# PEER REVIEW OF SACRAMENTO VALLEY FINITE ELEMENT GROUNDWATER MODEL (SACFEM)

U.S. Bureau of Reclamation

Prepared by:  WRIME

October 2011

Figure 2. SacFEM Grid

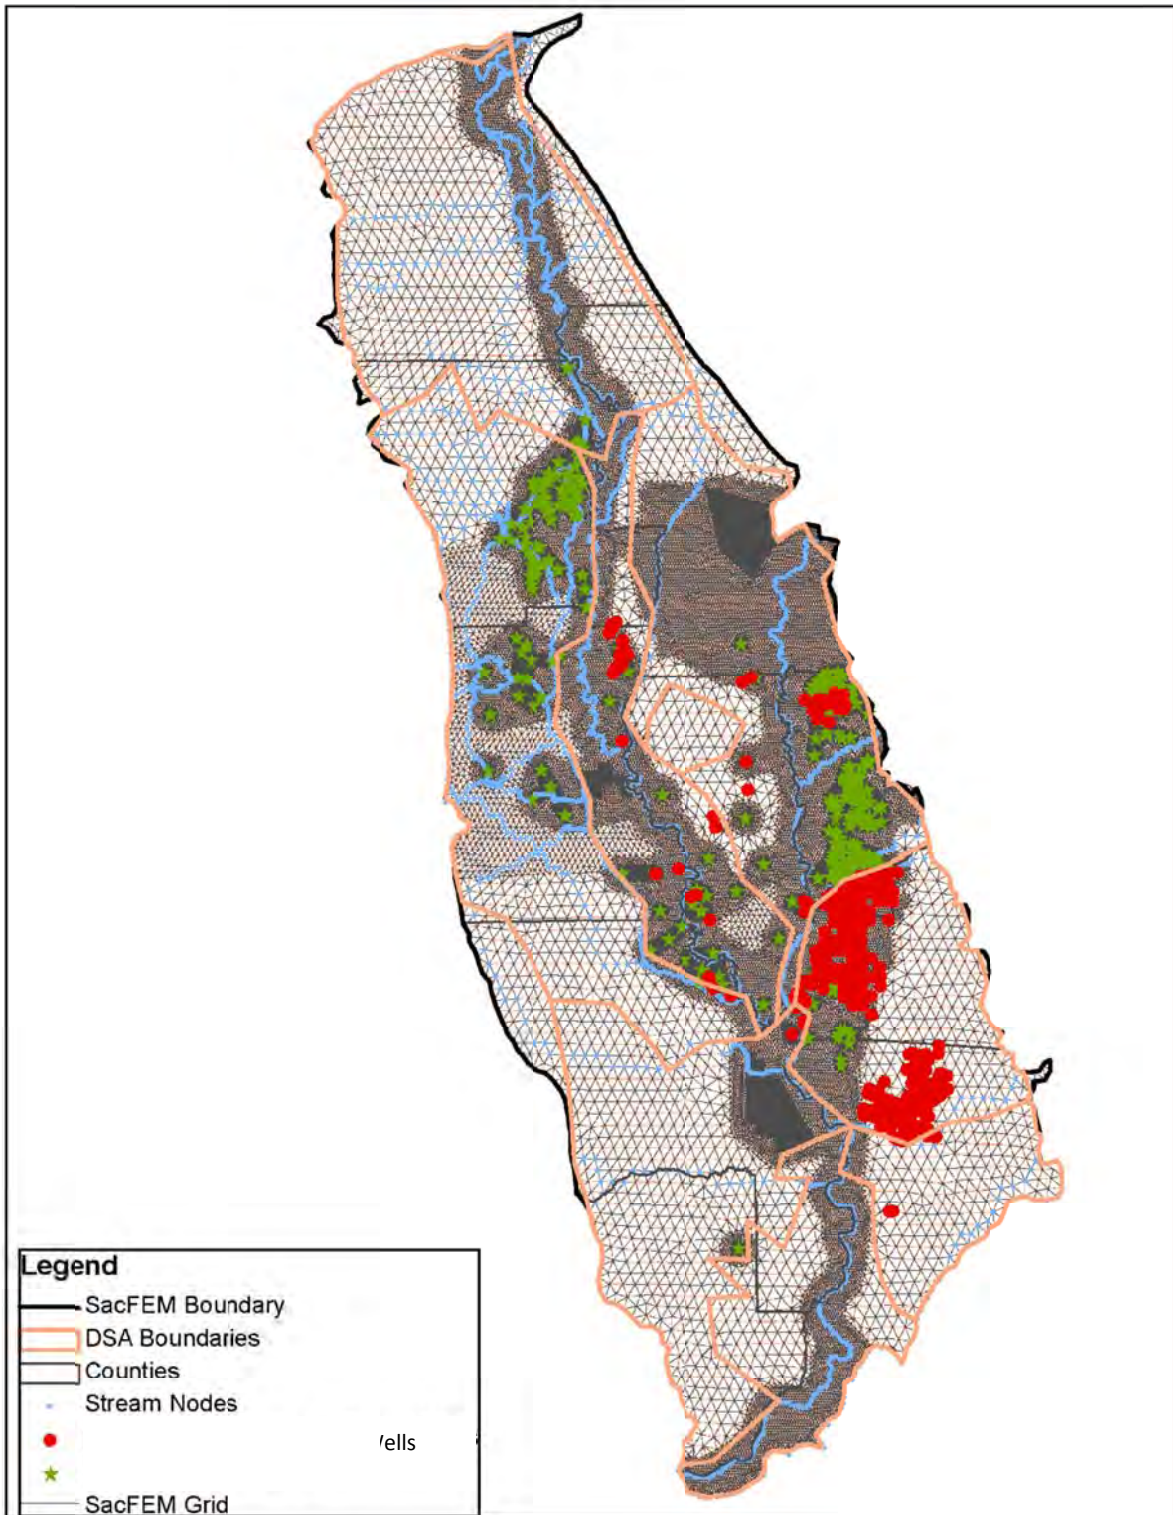
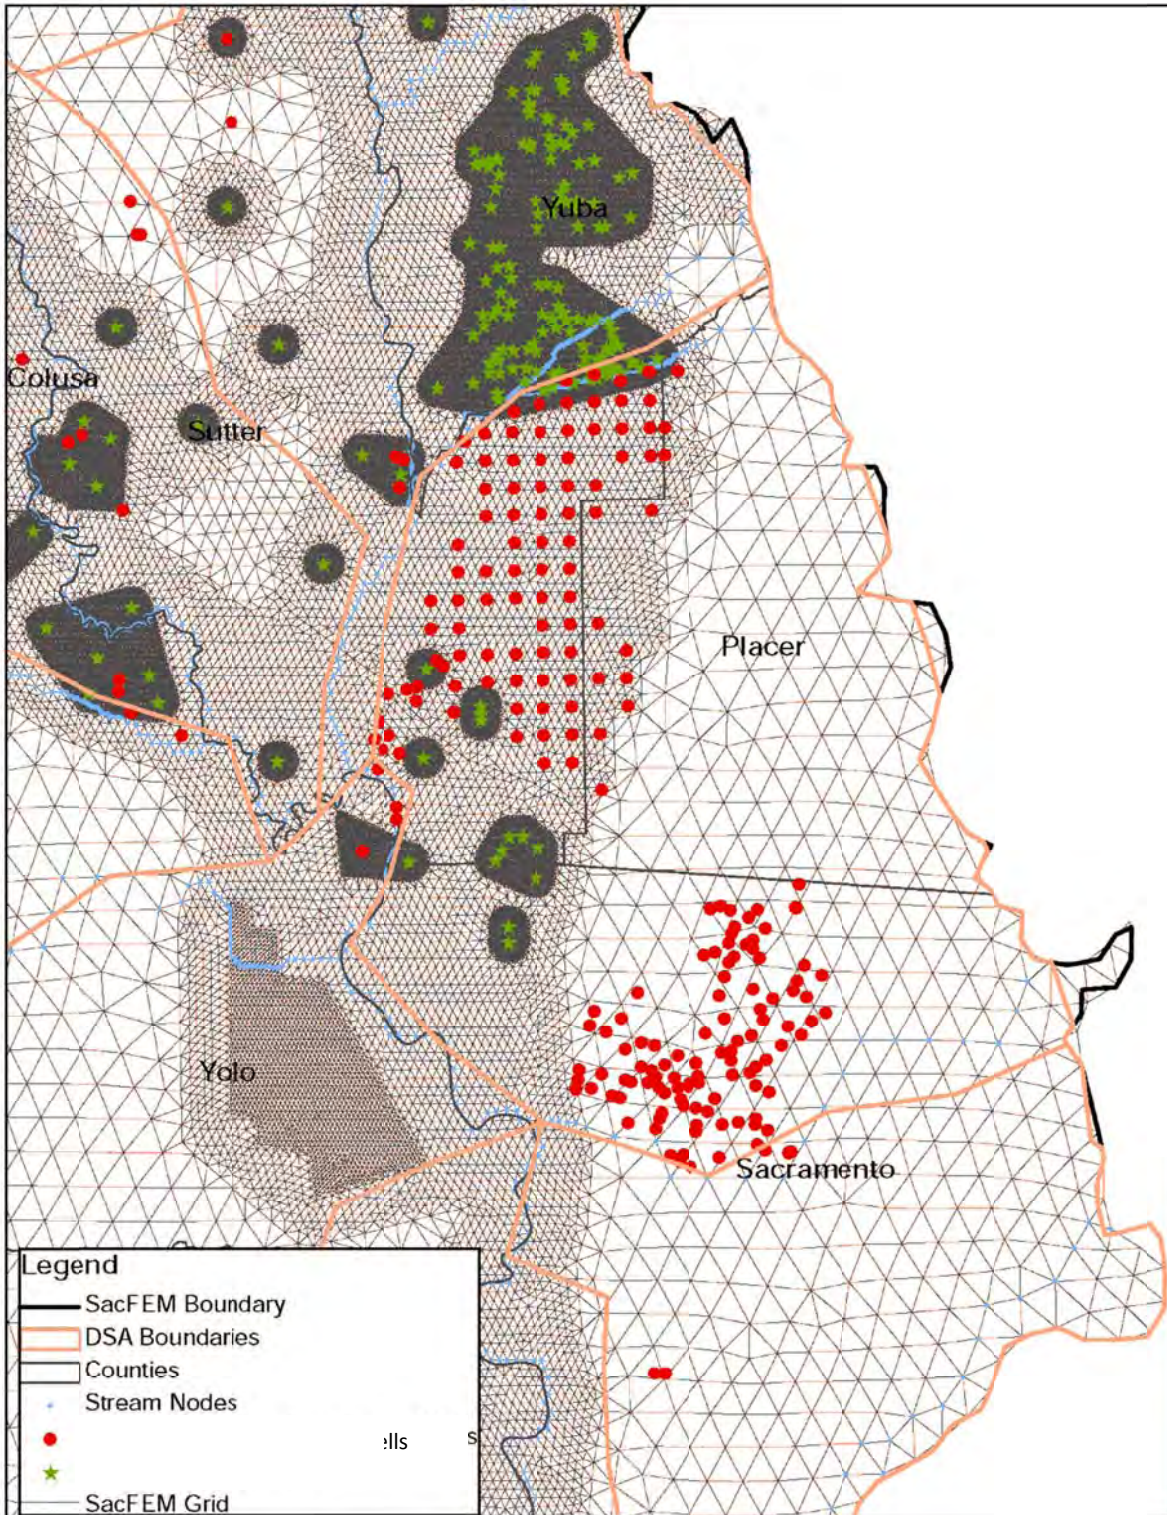
A comparison of SVWMP and the 2009 Drought Water Bank project wells locations with the SacFEM grid indicate that most project wells are located in the fine node spacing parts of the grid (Figures 2 and 3). However, Water Bank project wells in Sacramento County, east of Highway 50, are located in the coarse node spacing part of the grid (Figure 3). The coarser node spacing in this area does not support refined estimates of the effects of the Water Bank project in the Sacramento area. Project wells in the Sacramento area are recommended to be excluded, or the SacFEM grid needs to be refined in the Sacramento area for evaluation of the impact of conjunctive use projects.

1. The grid is well sized for most project areas, other than the Sacramento area.

1. **Refined Grid in Sacramento County** – SacFEM does not represent projects in the Sacramento area with refined grid. Refined grid should be used for this area, should SacFEM be used for project analysis in Sacramento County.

Figure 4. 2005 Land Use

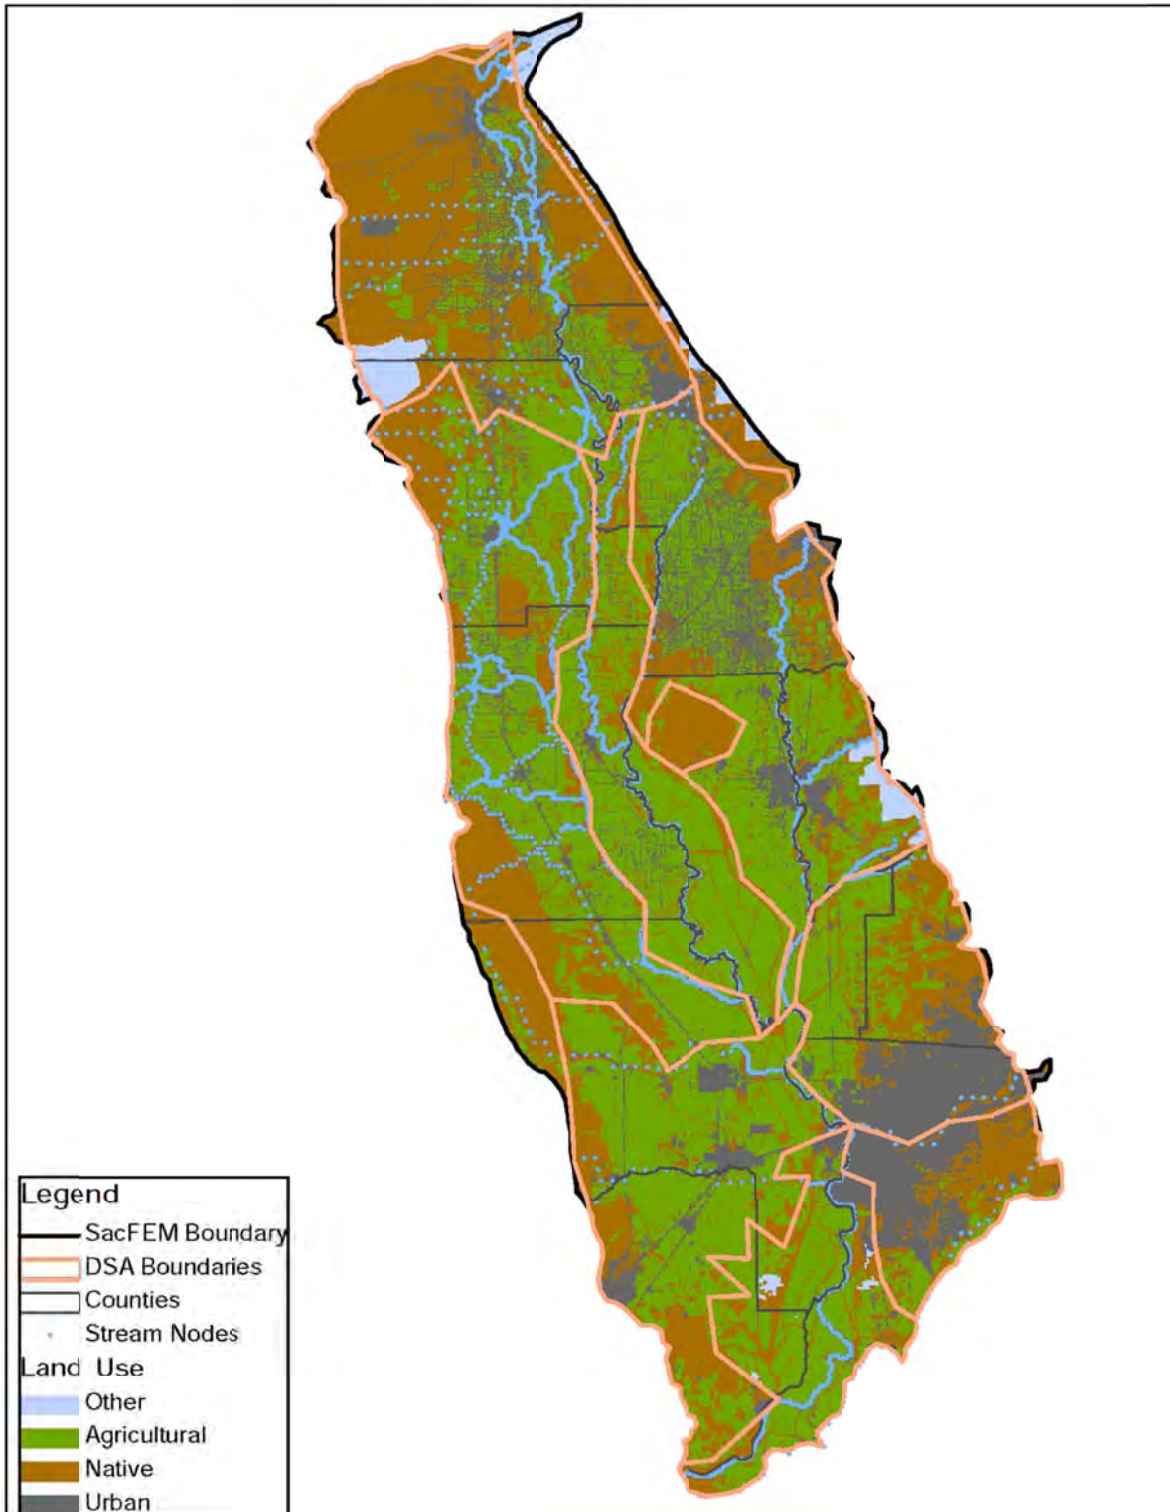
SacFEM and the IDC model use land use data for estimation of groundwater pumping and deep percolation during the 1970-2003 calibration period (Figure 4). The land use and cropping data are from DWR field surveys from several different years spanning from 1994 through 2003 (Table 1), and are assumed to represent approximately the 2005 level of development. It is assumed that no significant land use changes have occurred during the 1970-2003 period. However, other historical land use survey data are available from DWR for 1967, 1980, 1993, and 2000.

The use of only the 2005 level of development results in mismatch of the long-term changes in groundwater elevations in several calibration wells. The increase in urban areas will result in changes in groundwater pumping and elevation. This is evident in simulated groundwater elevations in calibration wells in the vicinity of the cities of Sacramento, Woodland, and Chico.

Additional historical land use information is recommended to be used for SacFEM and the IDC model to improve model calibration and obtain a better match of the long-term trends in groundwater elevation. Historical land use is not needed for analyzing the proposed projects; however, if SacFEM is better calibrated, it will have an improved estimate of the effects of the conjunctive use projects.

Figure 5. 2005 Crop Acreage

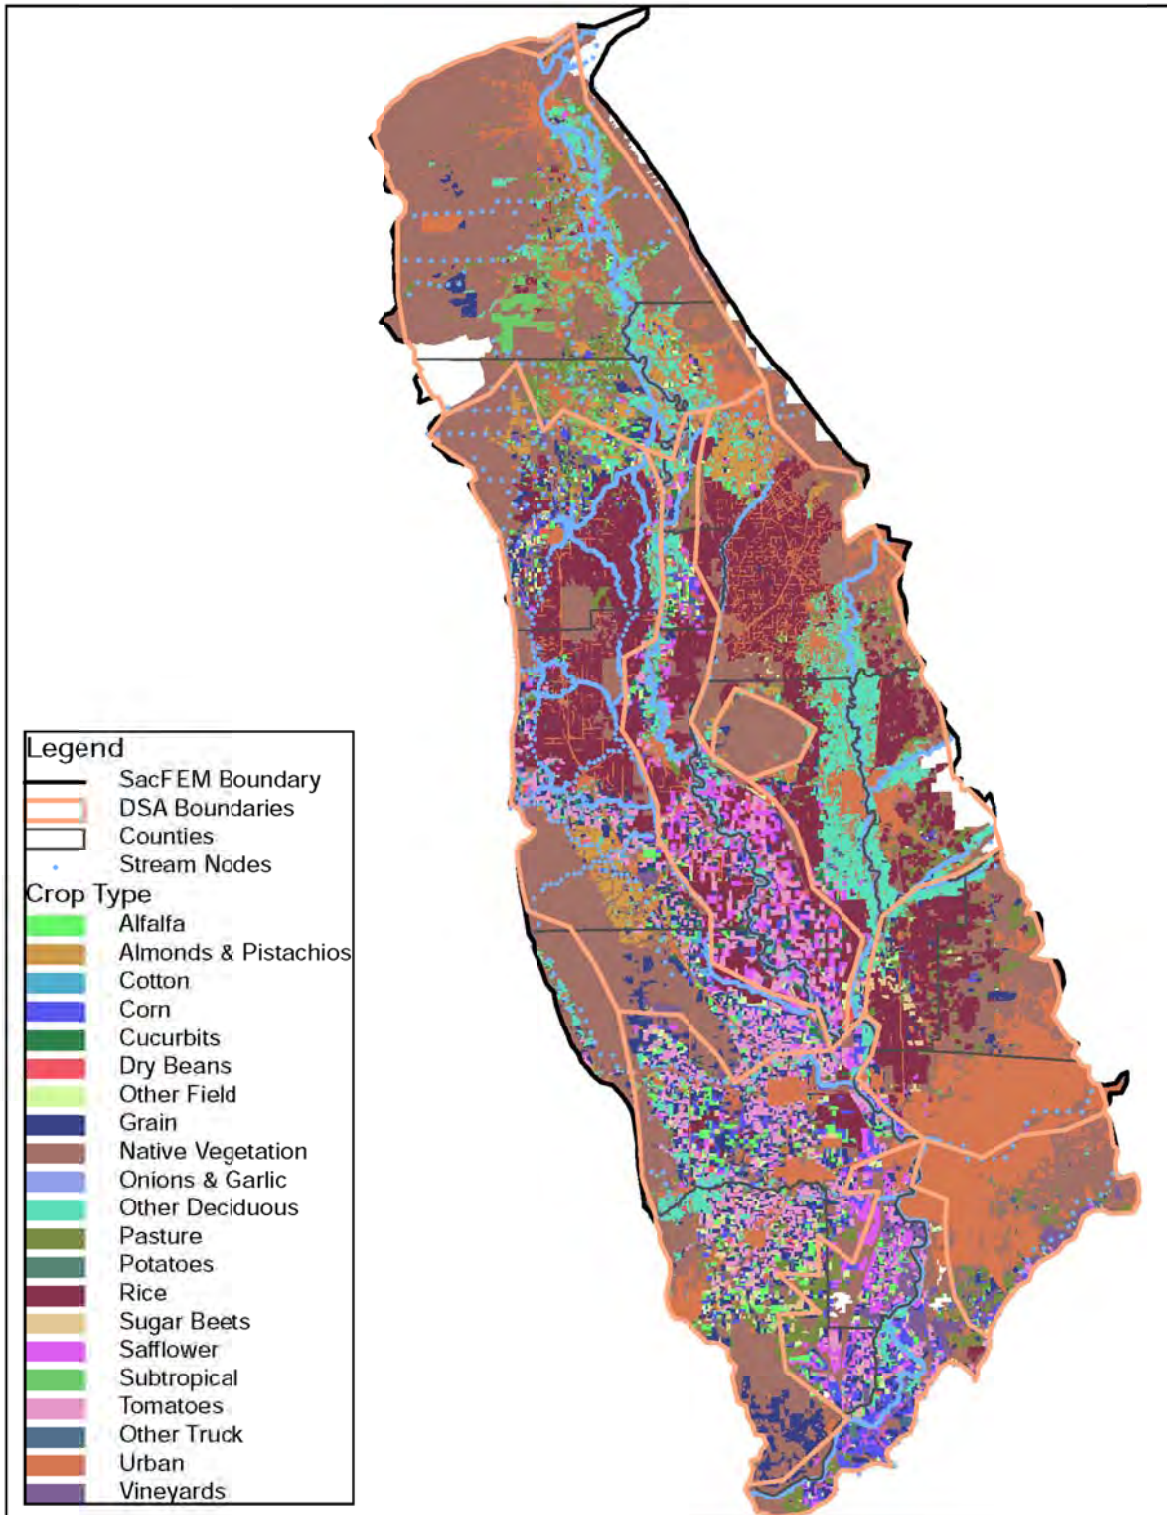
SacFEM and the IDC model use only the 2005 level of development crop mix data for the 1970-2003 calibration period (Figure 5). Similar to land use data, it is assumed that no significant changes to crop acreages have occurred during this period. Other historical land use survey and crop acreage data are available for 1967, 1980, 1993, and 2000. Figure 6 and Table 2 compare crop acreages and crop mix distribution of the Central Valley Groundwater and Surface Water Simulation Model (C2VSIM) with SacFEM crop acreage data. Alfalfa and pasture acreage reduced from a total of 25.1% in 1967 to 11.4% in 2005. Rice acreage varied from 25.2% in 1967 to 32.3% in 2000. Orchard acreage varied from 16.4% in 1980 to 24.4% in 1993.

Historical land use and cropping patterns for 1970-2003 indicate major changes in crop mix over time. These changes affect the historical estimates of agricultural water demand, agricultural groundwater pumping, and deep percolation. It is recommended to use historical crop acreage data for improved calibration of SacFEM and IDC models. A better calibrated SacFEM will have an improved estimate of the long-term trends in groundwater elevation as a result of future conjunctive use projects.
